Expert Witness Report

DR-04 – Civil Engineering and Costing

Amendment C387ggee to the Greater Geelong Planning Scheme

Jetty Road Urban Growth Area – Stage 2

Figure 9: SMEC Concept Design (Source: Water Technology Southern Waterway SWMS, 6 September 2023)

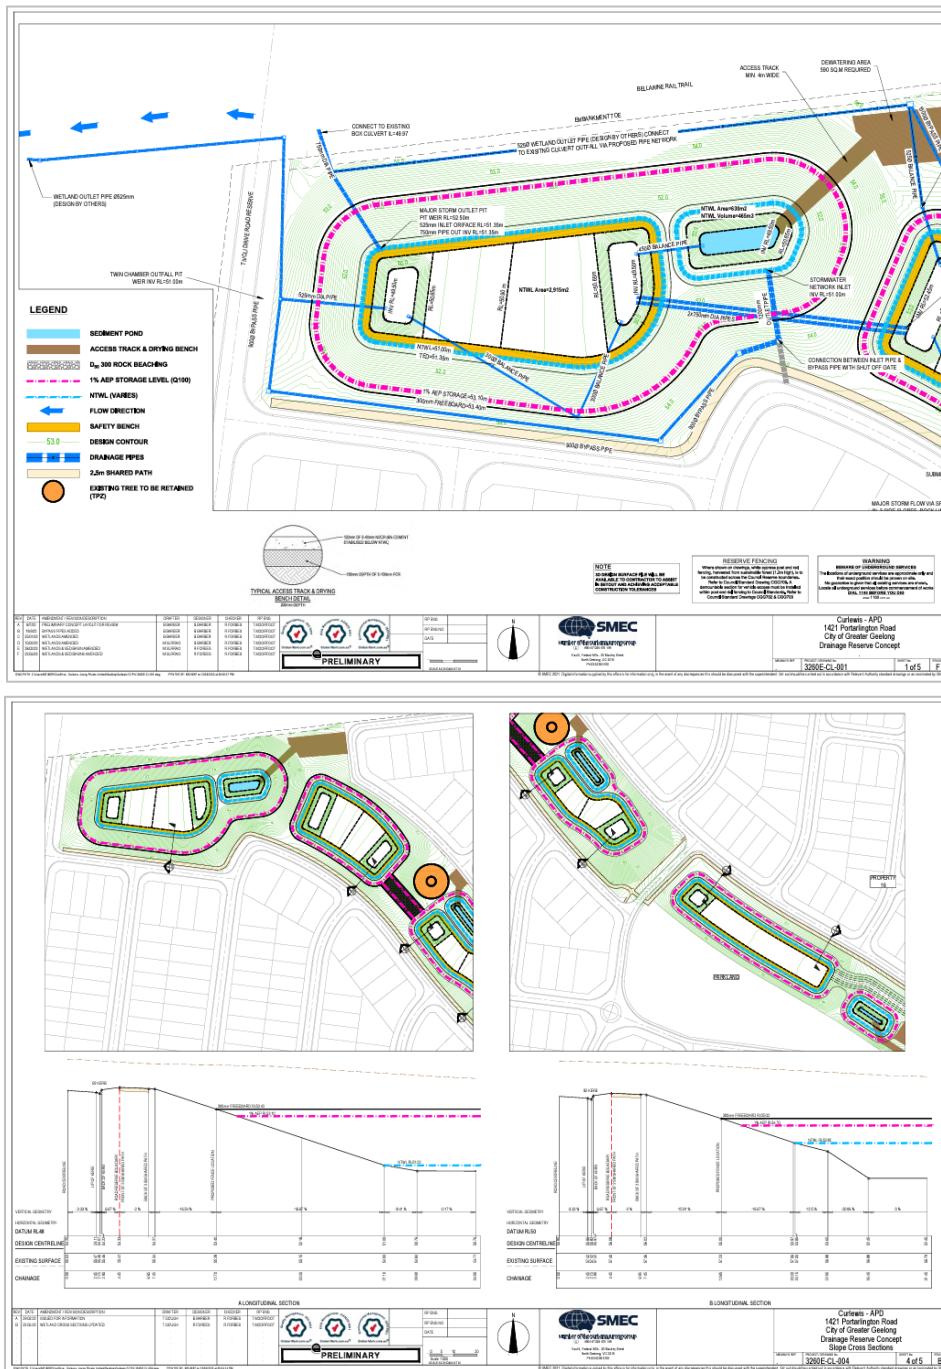
28. Within Appendix C of the Southern Waterway SWMS is a concept design for DR-04 prepared by SMEC and reviewed by Water Technology. The concept design exhibited is Revision F (5 sheets) which contains layout plans and cross-sections with design level information.

29. It is understood that the concept design has undergone extensive review and consultation with Council and the CCMA. Based on the summary of consultation provided in expert witness instructions located in **Appendix B**, the understanding of consultation with Council regarding the Concept Design and associated hydraulic modelling is as follows:

- (a) Council had provided in-principle agreement regarding the design for the southern waterway and wetlands and the overall Stormwater Management Strategy (SWMS), including provision of an online system.

- (b) On 5 April 2023, Council rejected the concept and design on the basis that it did not demonstrate compliance with its standards, including IDM, Council Design Note 2 & 3, Council Landscape Standards Manual and Melbourne Water Constructed Wetland/Waterway Design Manuals.

- (c) Council also stated that the slope and construction of the batters should be adjusted to avoid any need for safety fencing, and that wetlands should be located offline to waterways.

7. The Concept design associated with DR-04 is an appropriate design solution for the subject site based on civil engineering judgement.
